UNITED STATES OF AMERICA U.S. NUCLEAR REGULATORY COMMISSION

In the Matter of: SOUTHERN NUCLEAR OPERATING CO. License Amendment Application for Combined Licenses NPF-91 Vogtle Electric Generating Plant Unit 3 Docket No. 52-025-LA-3 NRC-2008-0252

PETITION FOR LEAVE TO INTERVENE AND REQUEST FOR HEARING BY THE BLUE RIDGE ENVIRONMENTAL DEFENSE LEAGUE AND ITS CHAPTER CONCERNED CITIZENS OF SHELL BLUFF REGARDING SOUTHERN NUCLEAR OPERATING COMPANY'S REQUEST FOR A LICENSE AMENDMENT AND EXEMPTION FOR UNIT 3 AUXILIARY BUILDING WALL 11 SEISMIC GAP REQUIREMENTS, LAR-20-001

Figure 1: Plan View Showing Area of Non-conformance²

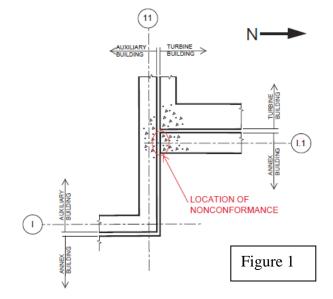
south minimum seismic gap
requirements above grade between the
nuclear island and the annex building
west of Column Line I from elevation
141 feet to 154 feet to accommodate asbuilt nonconformances in the
construction of Unit 3. See Figure 1 at
right.

This statement by SNC is incorrect. The "as-built" condition of the wall in question was correct at the time it was built. Its most recent location is not an "as-built localized nonconformance". Without human intervention, the wall moved after it was constructed because the NI is sinking. Gundersen Declaration paragraphs 15–17.
